Collected comments on Section 5 of draft standard D1 (PART 2)

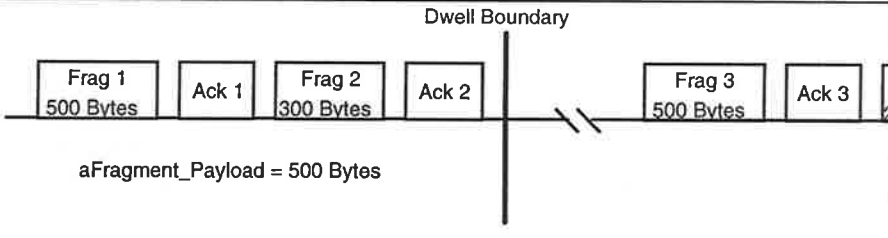
5.4.4	C. Thomas Baumgartner	t	Delete last sentence. Replace with "Until the next version of this specification details the PRNG this feature can't be implemented in 802.11 compliant networks for interoperability reasons."	Have to say this unless there is a method for WEP capable STA's to keep track of each STA's capability in ESS and send in clear when the destination is not WEP capable.

5.4.4	David Bagby	T	<p>2.WEP Algorithm Specification</p> <p>The specific PRNG algorithm is unspecified at present. Reviewers of this draft are encouraged to comment on appropriate PRNG algorithms for adoption by 802.11.</p> <div style="border: 1px solid black; padding: 5px;"> <p>The PRNG must be specified to enable compatible implementations of WEP. This reviewer has concluded that for several reasons RC4 from RSA is the appropriate alg to choose. The reasons include efficiency of implementation and the enhanced chances for export offered by the unique status of RC4. This reviewer can not vote to forward the Standard for sponsor ballot until the PRNG alg is specified.</p> </div>	See imbeded comments and annotations

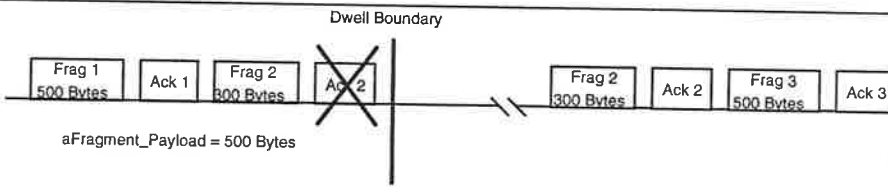
5.5	Bob O'Hara	E	update to reflect new sequence control semantics.	
5.5	C. Heide	e	last paragraph last sentence, replace "than" with "then"

5.5	Geiger	E	Whenever possible, the size of the payload of a fragment shall be some fixed number of bytes	Good, I would hate to see it be some variable number of sheep. What does this mean?
